Our ref: OUT21/828 ; RPI21/001

Requirement notice

RPI21/001 BMA – Saraji East

Information required for assessment against SCA criteria

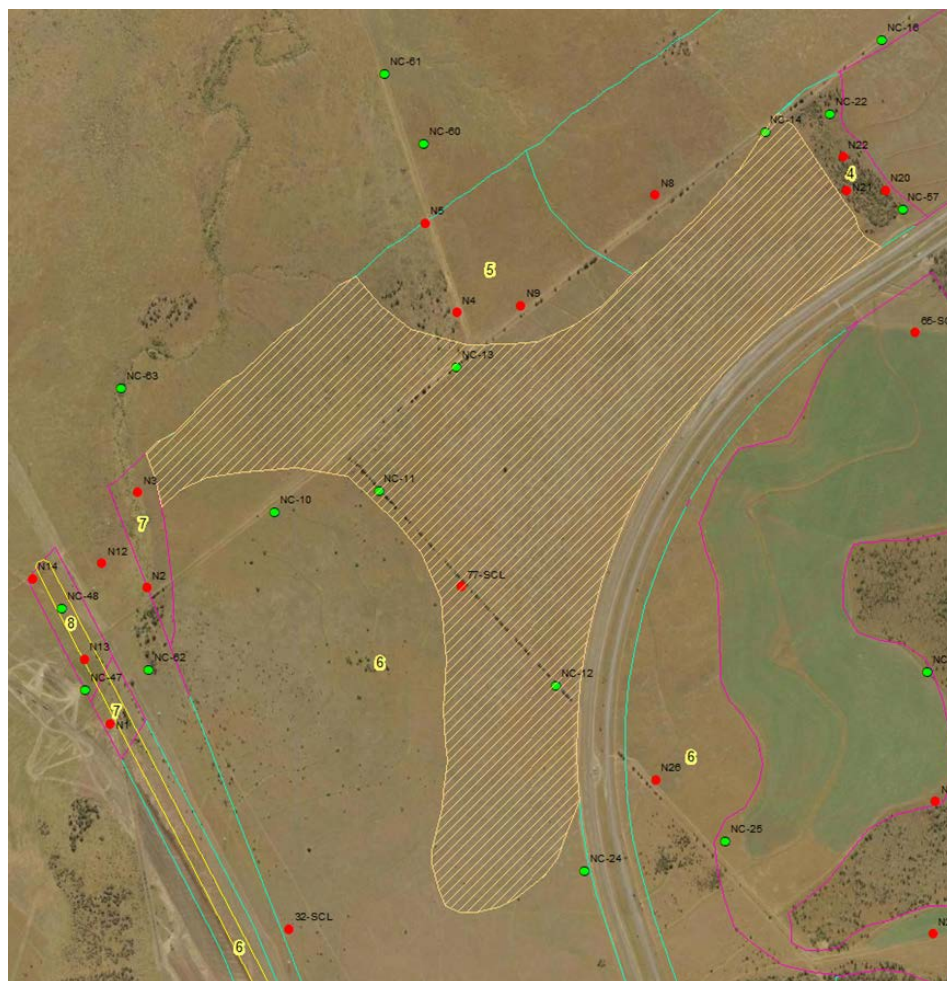
3.	<p><u>Issue:</u></p> <p>Map Unit 6 is a complex map unit, with the evidence provided by some of the check sites in the SCL Assessment Report not providing conclusive evidence to confirm the presence/absence of SCL. For example, the check site photographs of NC11 (classed as non-compliant SCL by the SCL Assessment Report) appears to be similar to the soil surface photograph of 77-SCL which is classified as compliant SCL.</p>

Due to the complex nature of Map unit 6, more information is required to assess the extent of non-compliant SCL. In particular, the area surrounding site 77-SCL (compliant SCL) requires additional analytical sites to delineate the SCL extent.

As the minimum map unit area for the Western Cropping Zone is 10 ha, additional sites are required to accurately delineate the extent of the compliant SCL. Given the inconsistencies described above between the field descriptions (e.g., in particular the field texture, surface characteristics and soil structure, laboratory particle size analysis, ASC and photographic evidence), it is difficult to confirm the field textures and structure described in detailed sites and particularly the field textures and surface condition of the check sites.

- (a) Confirm the extent of compliant SCL and non-compliant SCL within Map Unit 6, focusing the additional analytical sites within the area depicted in Figure 1 (see below). All map units still need to conform with the required site density of Table 3 of the RPI Act Guideline 08/14.
- (b) If additional areas of SCL (more than 10 ha) and map units are identified within Map Unit 6, provide additional analytical sites to confirm the SCL compliance of the remaining areas of the Map Unit.
